REPORT AMENDED BY STAFF 5-14-87
CITY PLANNING COMMISSION

B. Special Permit to develop a 393 unit apartment complex in the R-2B (PUD) zone and LPPT-PUD

APPLC. NO. P87-168 **MEETING DATE** May 14, 1987 **ITEM NO.** 23

The applicant proposes to construct a 393 unit apartment complex on the site to be known as Shore Park at Riverlake (Exhibits A-D). One hundred ninety three (193) units would be constructed on site 16 and 200 units would be constructed on site 17. Proposed density for the project is 21.7 dwelling units per acre. Staff finds that the proposed complex conforms with the community plan and schematic plan designations for the site. A similar designed project (by the same developers) has been constructed on the northwest corner of West El Camino Avenue and Stonecreek Drive (South Natomas Community).

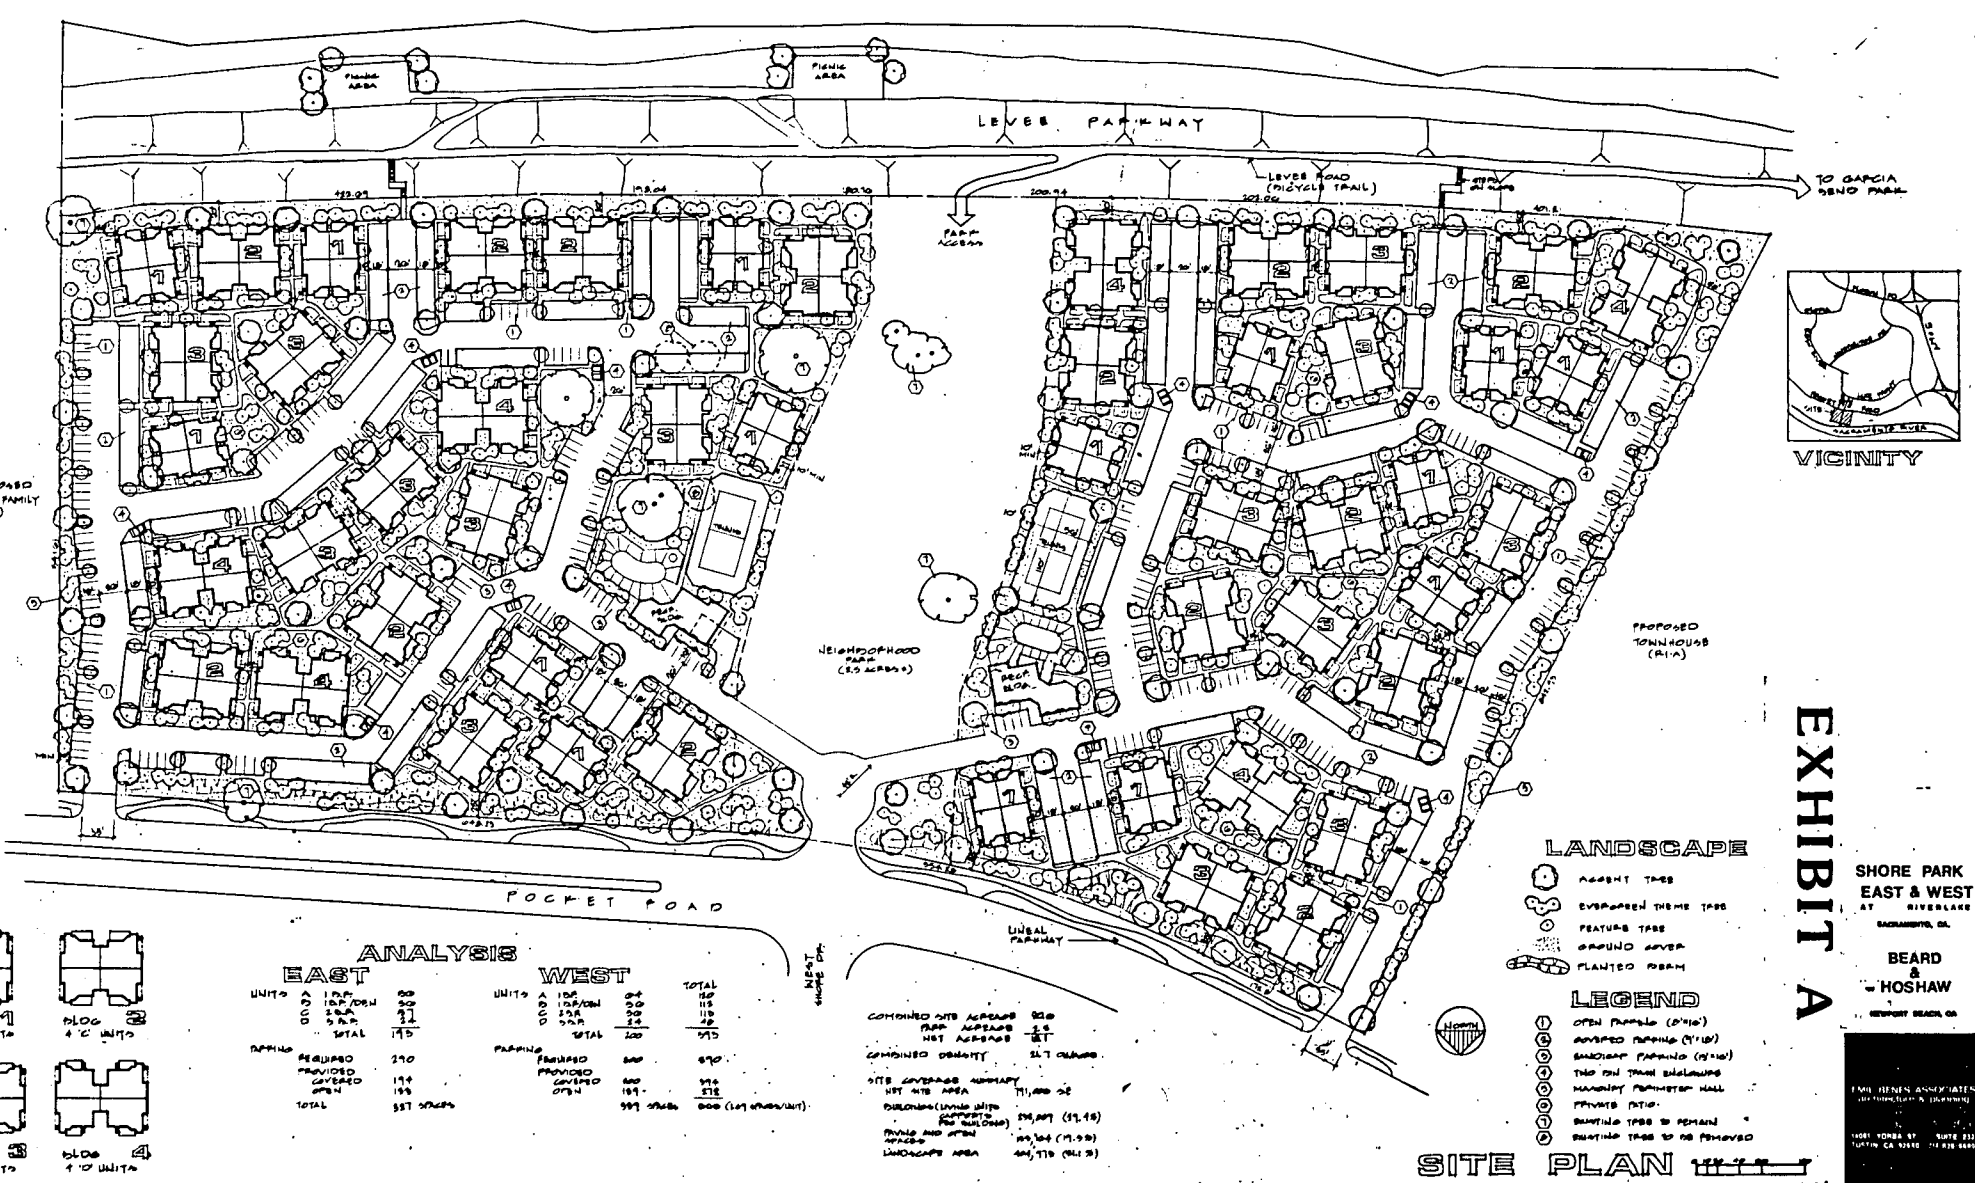
In designing the proposed site plan the applicant reduced the 30 foot landscape strip adjacent to the levee, which is indicated in the LPPT PUD Development Agreement, to 20 feet. The applicant has met with the City Parks Department concerning the reduction in landscaping and, in consideration for reducing the landscaping to 20 feet, has agreed to: construct the Sacramento River bikeway on the portion of the levee adjacent to their property; landscape the land side of the levee; and construct picnic facilities on the river side of the levee. Planning Staff finds that these public improvements will be beneficial to the community and has no objections to reducing the 30 foot strip adjacent to the levee to 20 feet.

The applicant has designed the project so that the proposed apartments are constructed in eight unit clusters and placed at various angles on the site, thus avoiding the monotony of long straight building lines. Adequate landscape setbacks are provided between building clusters and between the apartment clusters and the side and rear yard setbacks. A 25 foot front landscaped setback is indicated

adjacent to Pocket Road. Planning Staff recommends that physical barriers such as shrubs or three foot high fences or walls be located between berms in order to discourage access between the apartment units and the Pocket Road right-of-way and in order to screen the carports from Pocket Road.

Six hundred, sixty-six (666) parking spaces are indicated on the site plan. Three hundred, ninety-four (394) of these spaces are covered. These spaces exceed the minimum 616 spaces required by the Zoning Ordinance and LPPT - PUD Guidelines by 50 spaces. Uncovered spaces are a minimum of 10 feet from all property lines and covered spaces a minimum of 15 feet from the property lines as required by the PUD Guidelines. Planning Staff recommends that all carports have wood trim and use colors similar to the residential units.

Ten trash enclosures are indicated on the submitted site plan. These enclosures shall follow the requirements of the LPPT PUD Guidelines.

Private access gates to the two apartment sites have not been indicated on the site plan. If private access gates are proposed staff recommends that their location be subject to the review and approval of the Planning Director.

2. The applicant's plans indicate that several trees are to be retained and three are to be removed. The plans do not note either the size or species of these trees. The potentially significant impact can be reduced to an acceptable level by requiring the applicant to submit a survey of the trees on-site for the review and approval of the City Arborist. No trees shall be removed without first acquiring this approval. The applicant shall protect and retain those trees identified by the City Arborist for preservation by insuring the following to be complied with to the satisfaction of the City Planning Director and City Arborist prior to the issuance of a building permit.

5. Revised landscape shading and irrigation plans shall be submitted for Planning Staff review and approval prior to issuance of building permits. Plans shall indicate four foot high undulating berms in the setback area adjacent to Pocket Road. Physical barriers such as shrubs or three foot high fences or walls shall be located between the berms subject to Planning Staff review and approval;

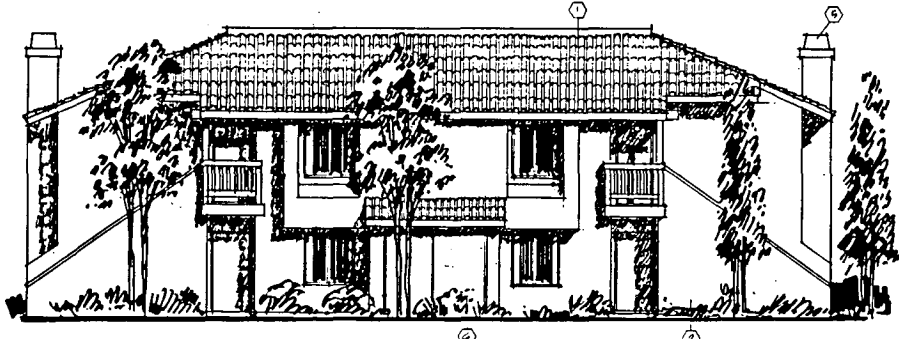
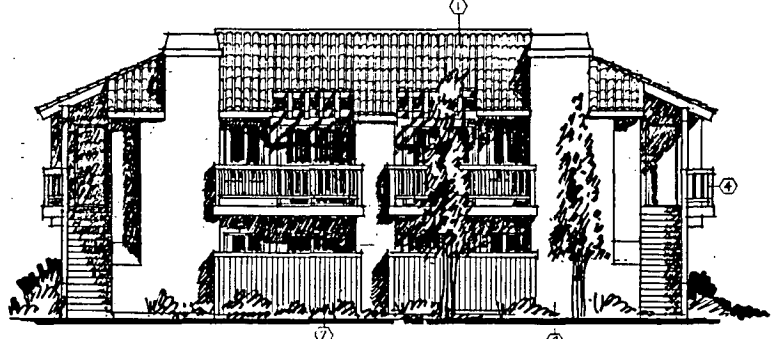
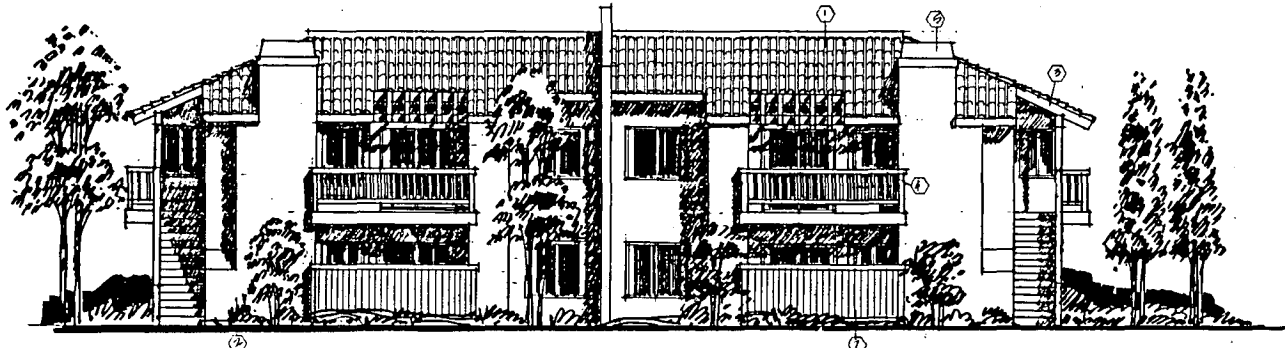
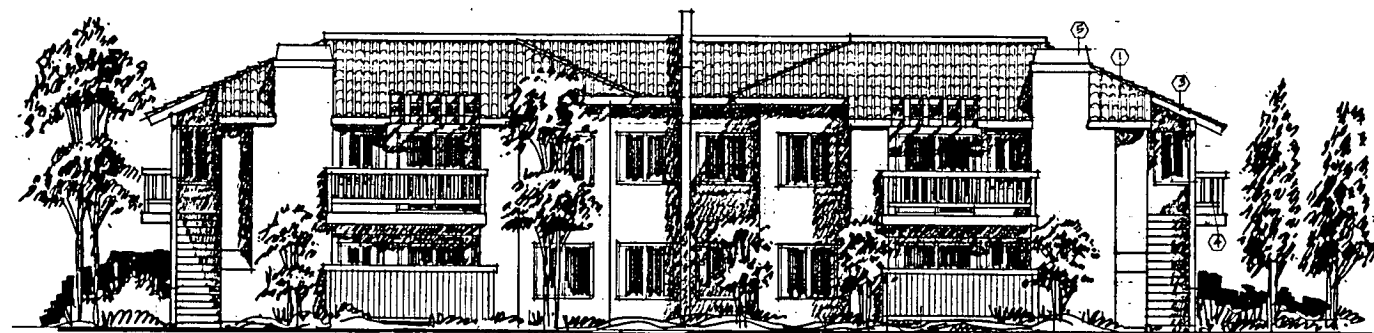
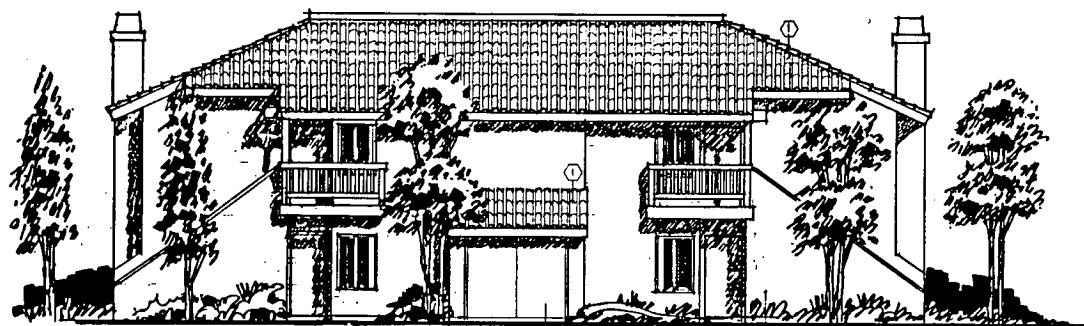
The proposed buildings are two-story (24 feet high) and have a variety of unit types ranging from one bedroom, one bath units to three bedroom, two bath units. Each unit type will have fireplaces and washer and dryer hook-ups. A Mediterranean theme is proposed for the building exteriors, with white stucco walls, blue-green trim and red clay tile roofs proposed as the exterior building materials. Staff finds the proposed buildings to be attractively designed and that they will be compatible with future residential uses in the surrounding area. Planning Staff recommends that balconies and patios, which are visible from Pocket Road and the public park, be screened by a solid wall in order to reduce visual clutter for persons viewing the patios and balconies from public spaces.

- The applicant shall comply with any measures deemed necessary to preserve the trees after review and approval of the tree survey.
- 15. Balconies and patios which face Pocket Road and the public park shall be screened by a solid wall subject to Planning Director review and approval prior to issuance of building permits;
- 16. The apartment complex shall be developed per the submitted site plan, elevations and floor plans;
- 17. The project shall comply with all applicable regulations of the LPPT-PUD Guidelines and the LPPT Development Agreement;
- 18. Prior to approval of the final inspection of the project by the City Building Division, the Planning director shall inspect the project for compliance with all conditions of the special permit;
